PLAN 4

PLANNING APPLICATION PLN-21-0137

3 BANKSIA GROVE, PERTH

WH712980 - PROPOSED UNIT DEVELOPMENT
(CENTACARE EVOLVE HOUSING)
3 Banksia Grove
PERTH

SITE PLAN
Drawn: kv
Date: 10 May 2021
Scale: 1:200

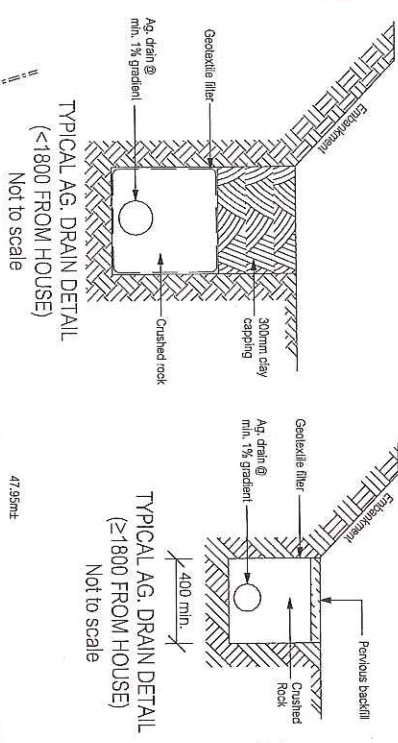
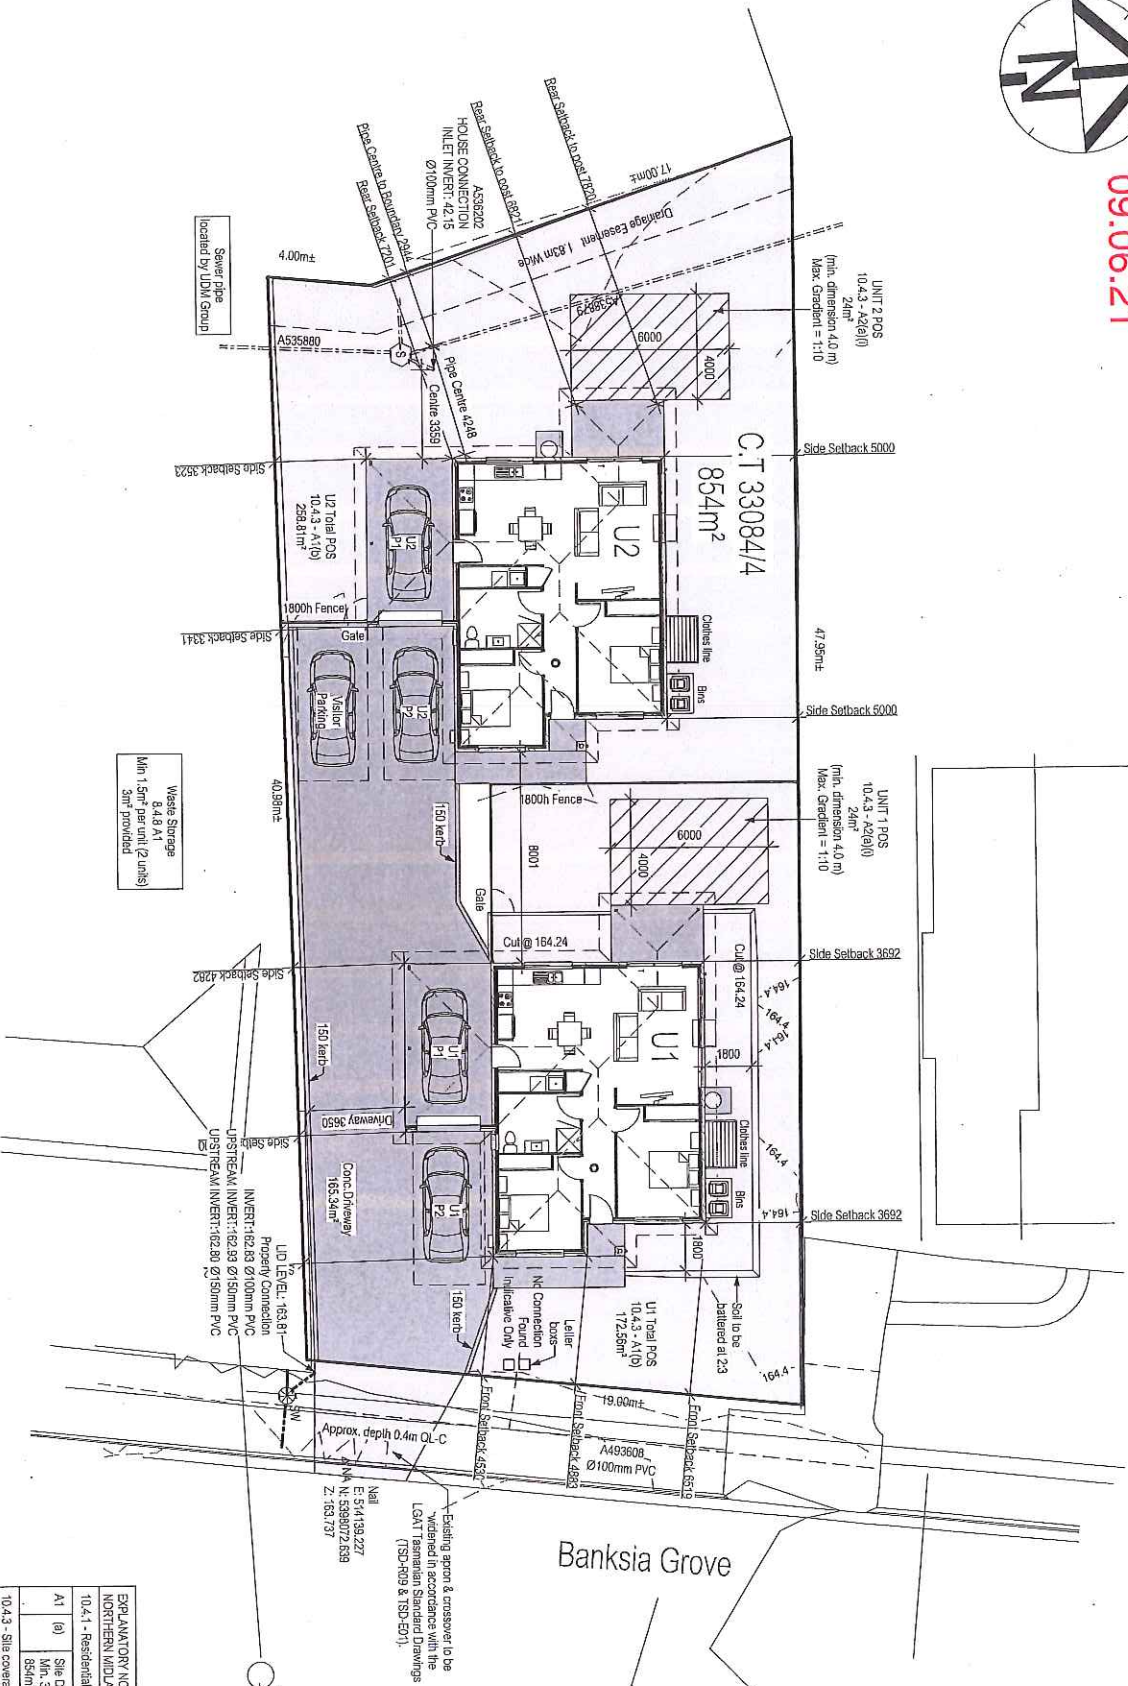
Existing spurs & crossovers to be widened in accordance with the L&M Transman Standard Drawings (TSD-P09 & TSD-E01).

The application mentions widening the existing crossover / driveway to help vehicles reverse from this property. Their plans show the existing cross over/driveway on the left hand side of the block, when in fact it is on the right hand side of it and is adjoining the crossover to our block, No 4 Banksia Grove Tasmania.

By creating a new crossover/driveway, traffic reversing from No 3 will not have as much road space due to other cars continually parked across the road opposite No 3.

If the units were turned around on the block to use the existing crossover, cars reversing would have far more road space when reversing towards existing driveways of adjacent houses 10 & 11 Banksia Grove double crossover, which will not have other vehicles parked in front of them. Also vehicles exiting No 3 will be reversing closer towards the end of the cul-de-sac where the road is half again wider.

We are also wondering what will happen to our existing joint crossover with No 3 if the units are built to these plans?

If this crossover is removed we will have problems when towing our caravan and turning right into Banksia Grove from our driveway

It does appear we have a drafting error with the note for it to be widened – this looks incorrect and we are in fact proposing a new apron/crossover.

We would happily mirror the site as suggested by the representor to utilise the existing crossover/apron, however it causes many planning problems by doing so including greatly reducing the northerly facing component of yard and sunlight to the dwellings This would then affect the amenities of the new dwellings and provide a less than ideal outcome. We see these items alone enough to outweigh the decision to flip the design

The issue raised by the representor regarding exiting the site. Upon the review from council to consider this necessary and/or of benefit, we would accept/support a condition on any permit issued to provide a 5.5m wide crossover and apron (current version is angled to a smaller crossover) to assist with vehicles turning onto the street.

We are unsure of the process or requirements around leaving the existing apron in place, but if it is of benefit to the representor, we have no issue with leaving it in situ. We will require guidance from Council as to the viability of this.
